工程指示 / 要求簡箋(E.I.)

工程指示編號：EI / 4847 / 23

工程名稱：將軍澳日出康城 11

工程項目：幕牆 大貨廠用配件 標準層 防火棉廠用

有關工廠新預裝防火棉

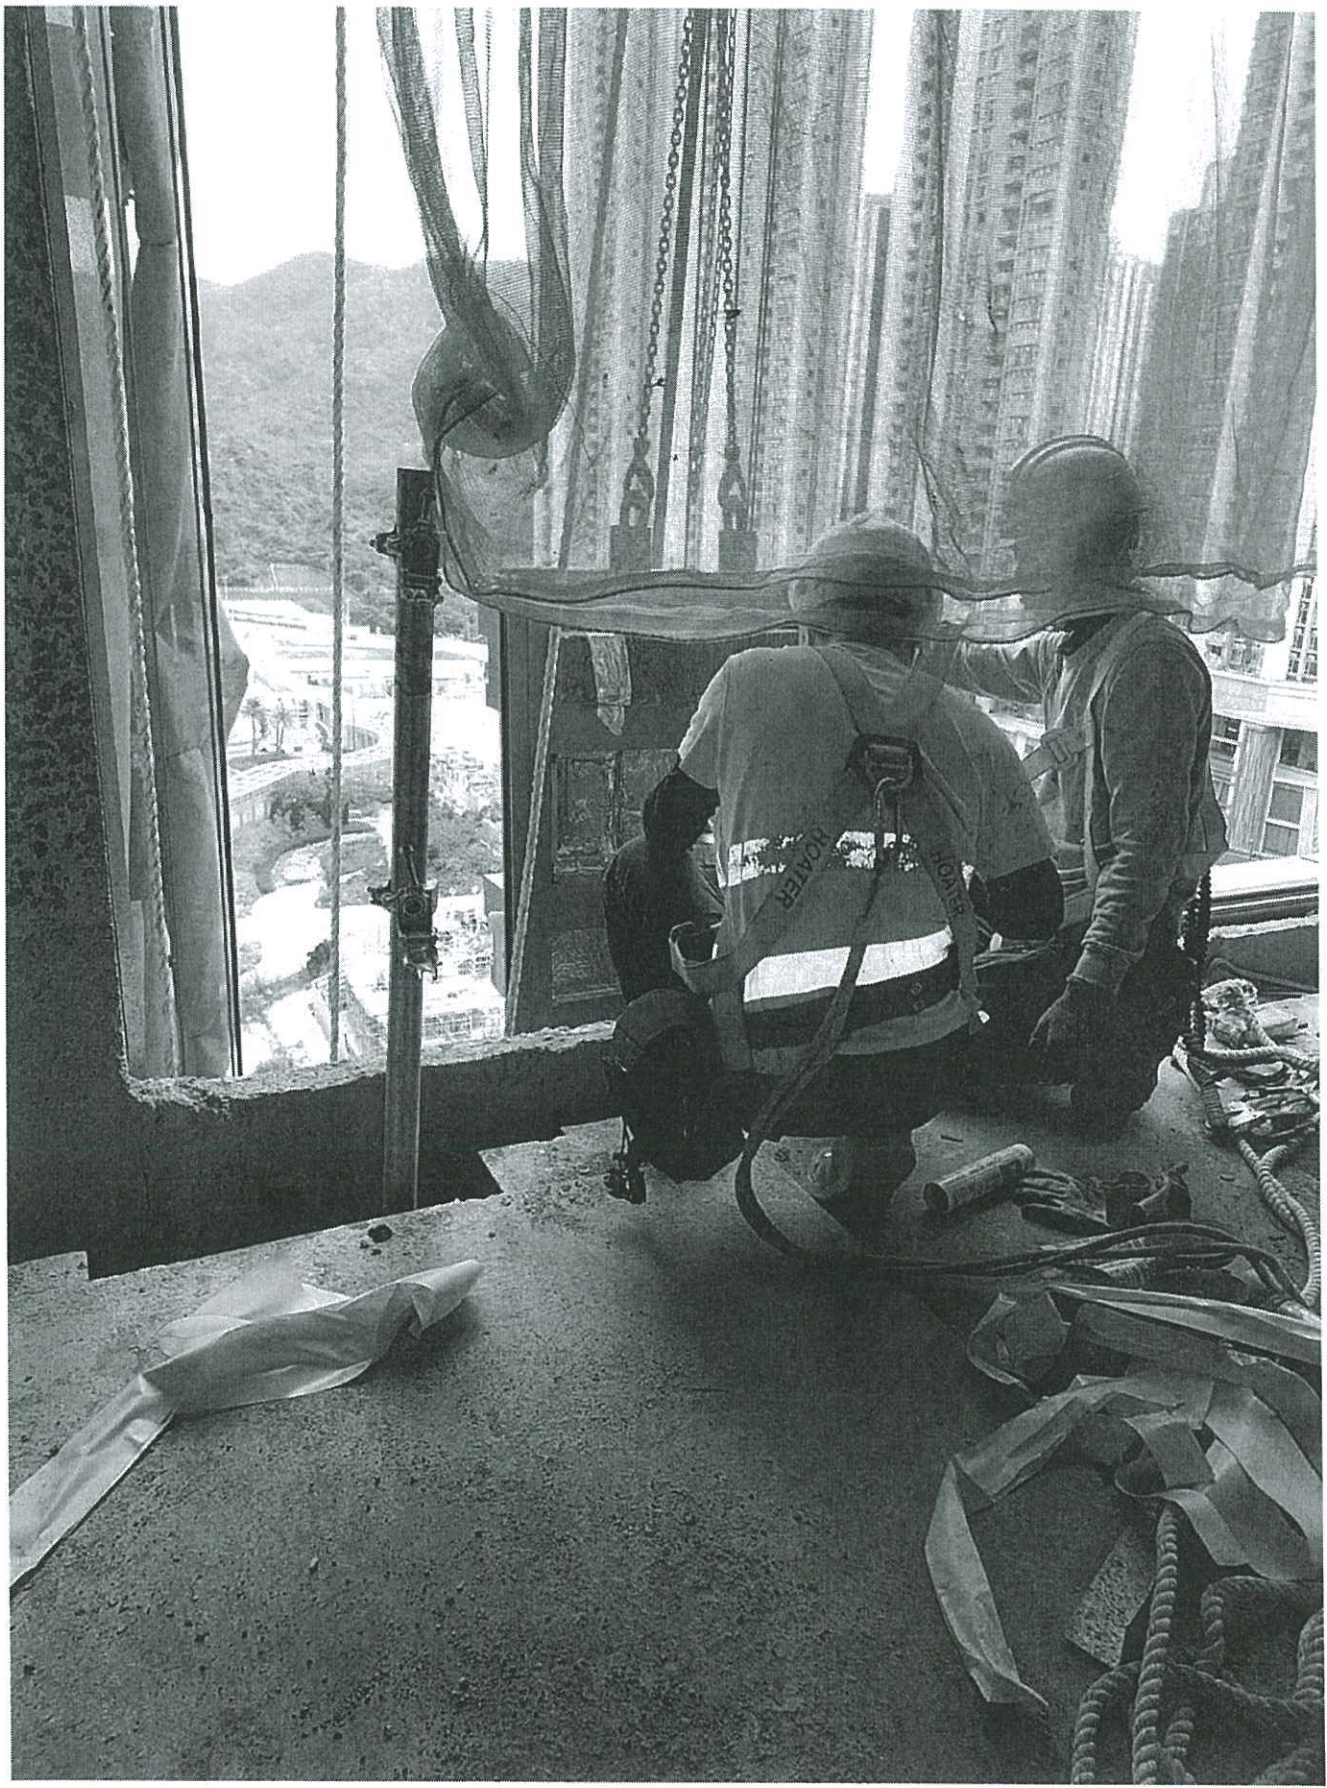
← 距離太小?

裝於水幕前
的飾線料
下1支飾線

由於棉托與
下面條飾線
間後橫料面
距離太接近
在裝單元件
過程中會相碰
裝不制單元
只碼口?

請收交
① 要拆原位置的棉托
不裝上
② 此後下批預裝請告知工廠預先
預留此個防火棉 (全個空間/凸出30)

↓ 需用錫紙包好
完整

Photo 1

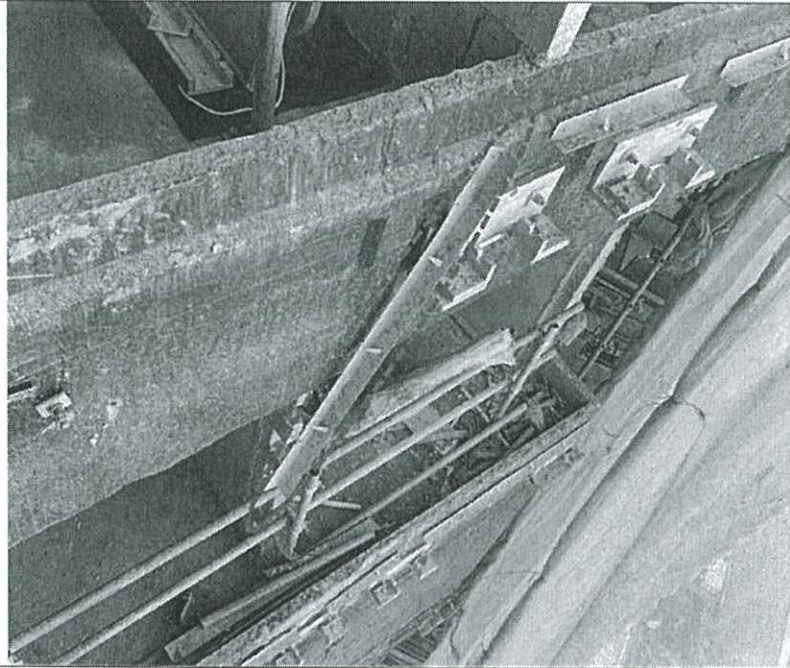
The retainer plate for fire insulation was observed to be damaged on the 12/F slab. It was removed after informed of MIDI.

Photo 2

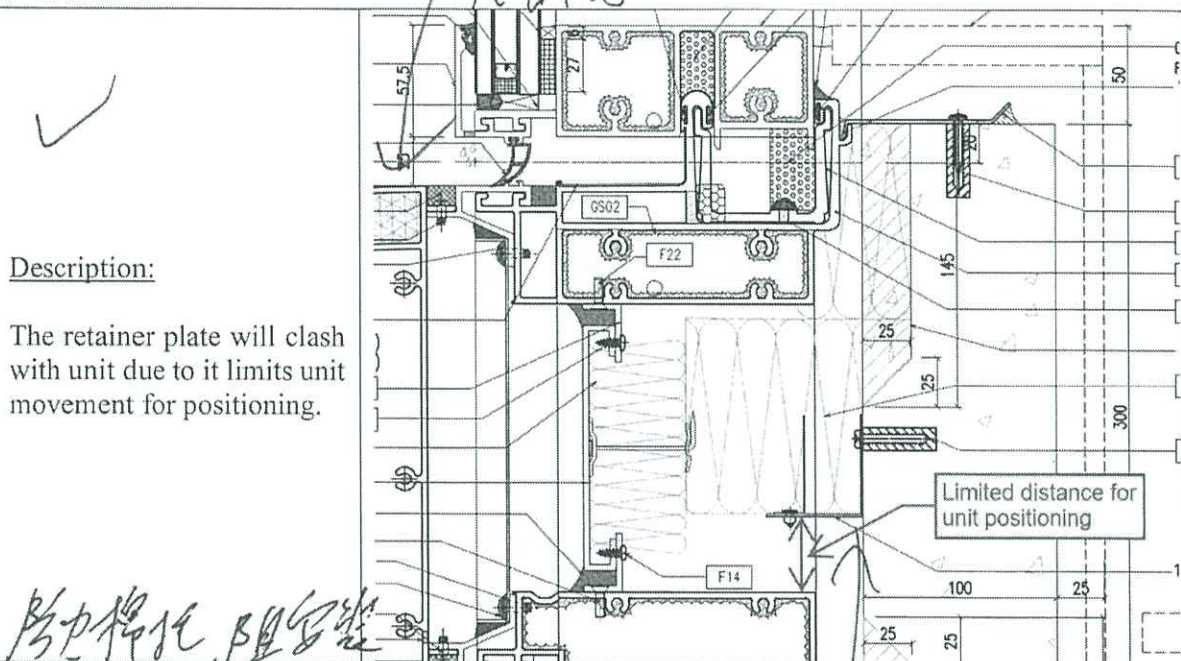
✓
防冲撞托架
拆除
Description:

The retainer plate was observed to be removed due to it will clash with unit during installation.

Photo 3

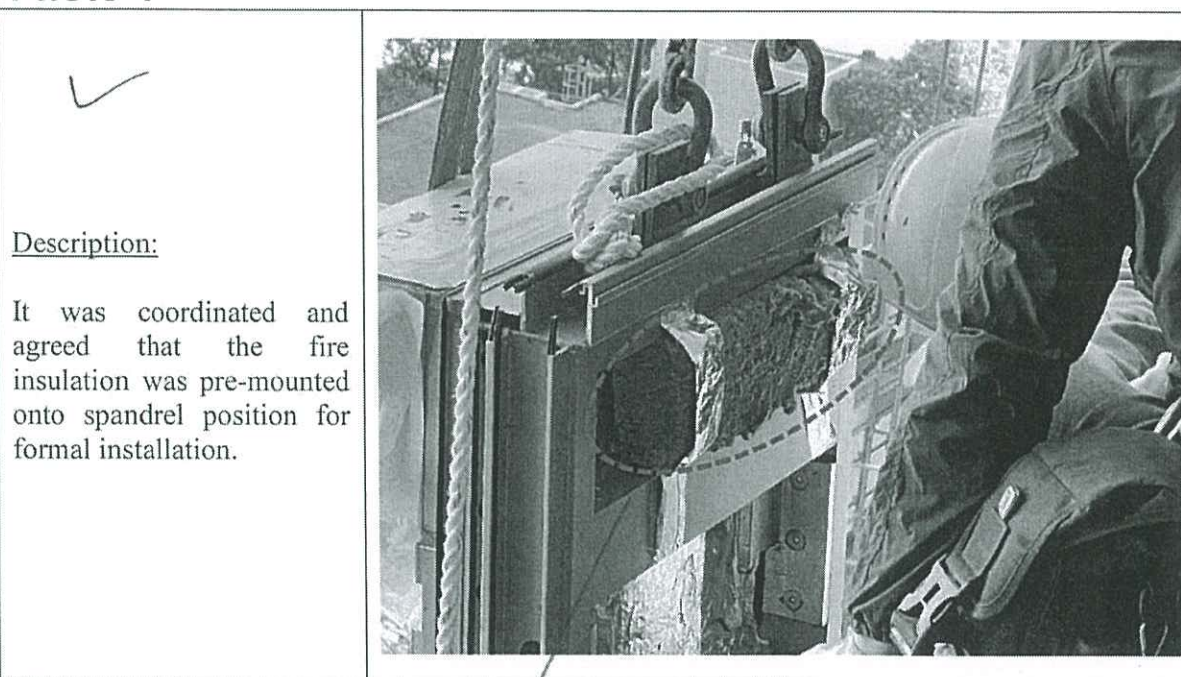
The retainer plate will clash with unit due to it limits unit movement for positioning.

防力掙托, 阻礙安裝
有鎖線等零件

X 掙托
